URGENT FIELD SAFETY NOTICE – BDDS-19-1617 BD Kiestra™ InoqulA™ / InoqulA+™

1 August 2019

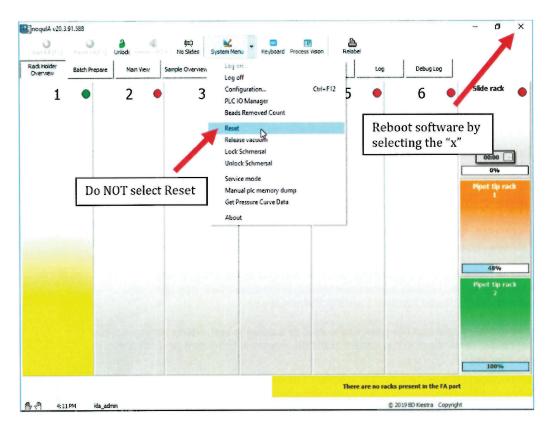
BD recently identified through a customer complaint investigation that an anomaly is present in InoquIATM / InoquIA+TM software version 20.3. This software anomaly has the potential to cause a mismatch between a specimen and plate. While it has not been ruled out that the anomaly can cause a mismatch in other instances, BD has observed that the mismatch can happen when following conditions occur together:

- •The InoqulA hardware is not operating, such as during a power outage, and
- •the pipette has already drawn a specimen waiting to be dispensed on a plate, and
- •the user selects the Reset function from the System Menu.

- 1. Do not utilize the Reset function from the System Menu of InoqulA software until further notice. Refer to the image on page 2.
- 2. In order to reboot the InoquIATM software, close the InoquIATM software application by selecting the "x" in the upper right corner. Refer to the image above. The InoquIATM software can then be restarted by double clicking the InoquIATM software's icon on the desktop.
- 3. Complete the attached Customer Response Form and return to the BD contact noted on the form so that BD may acknowledge your receipt of this notification.
